DS3112

TEMPE T3 E3 Multiplexer

REVISION C1 ERRATA

Figure 1. Timing Diagram

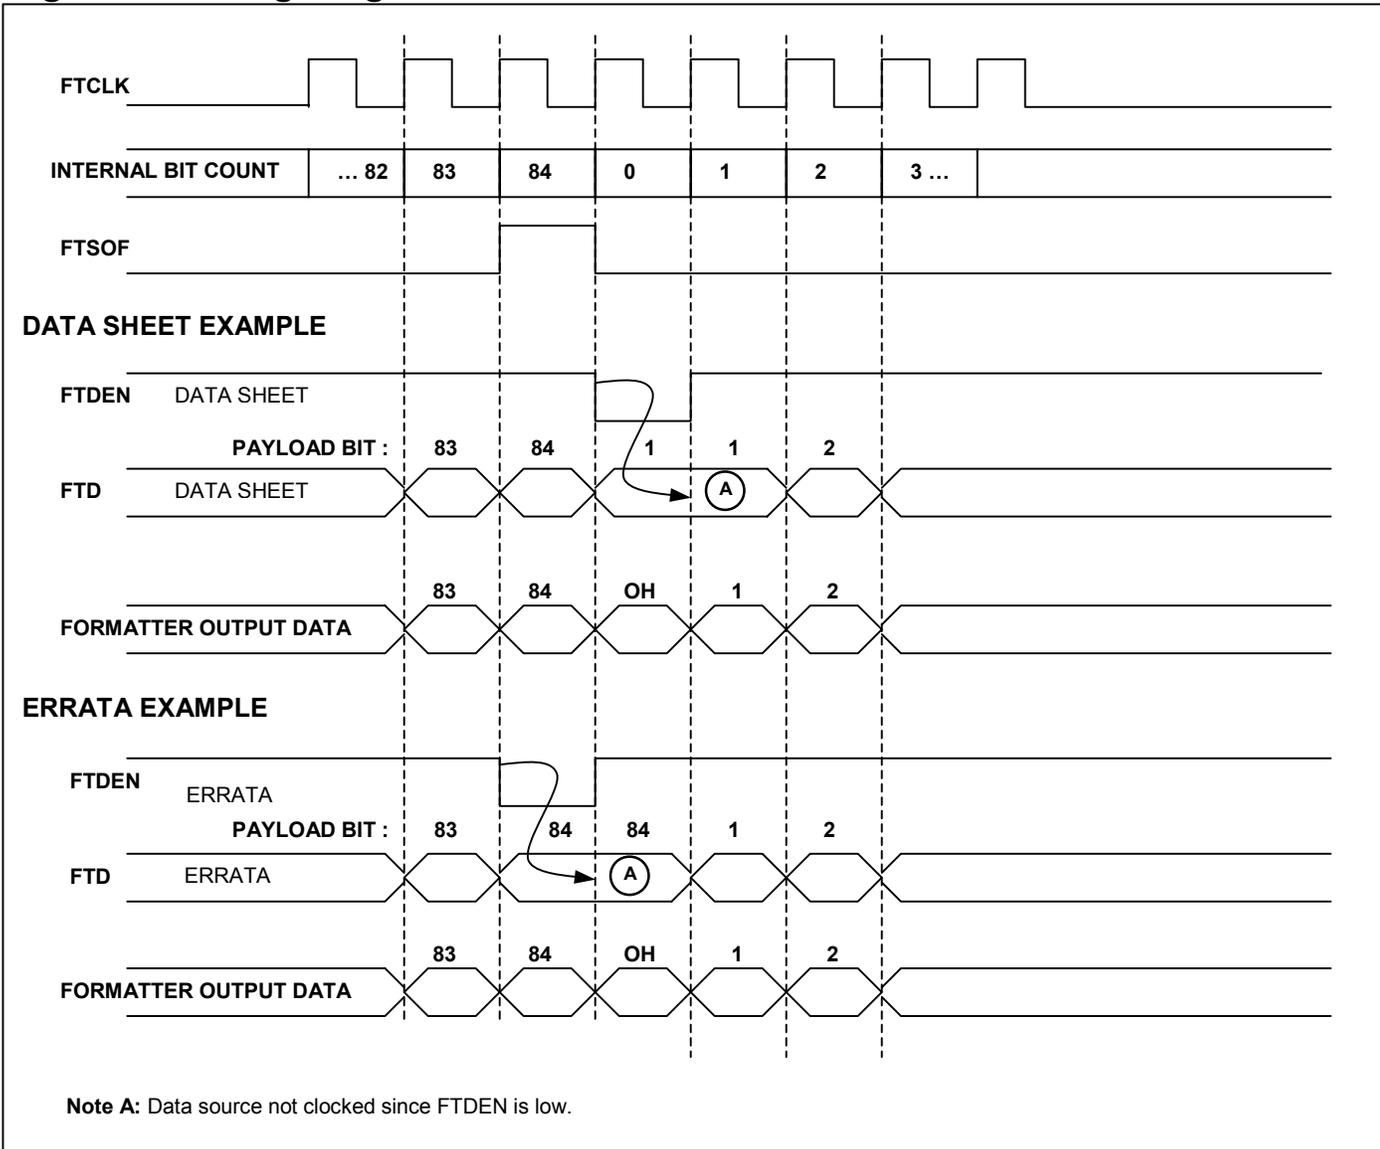
The FTDEN output pin (T3/E3—transmit formatter serial-data enable) pulses one clock cycle earlier than specified in Figure 2.4A of the DS3112 data sheet. This occurs in T3 mode only. FTDEN is early for both data-enable and gapped-clock modes of operation. This only affects unchannelized T3 operation; channelized T3 and E3 are not affected.

This erratum has no effect on the output data stream. Figure 1 shows that whether FTDEN pulses per the data sheet or one cycle early, the formatter output data is the same. The overhead bit is properly inserted between payload bit 84 and payload bit 1. The example in Figure 1 depicts the DS3112 where FTDEN is configured as a data enable. The gapped clock case is identical.

Use an external flip-flop to delay the FTDEN signal one clock cycle.
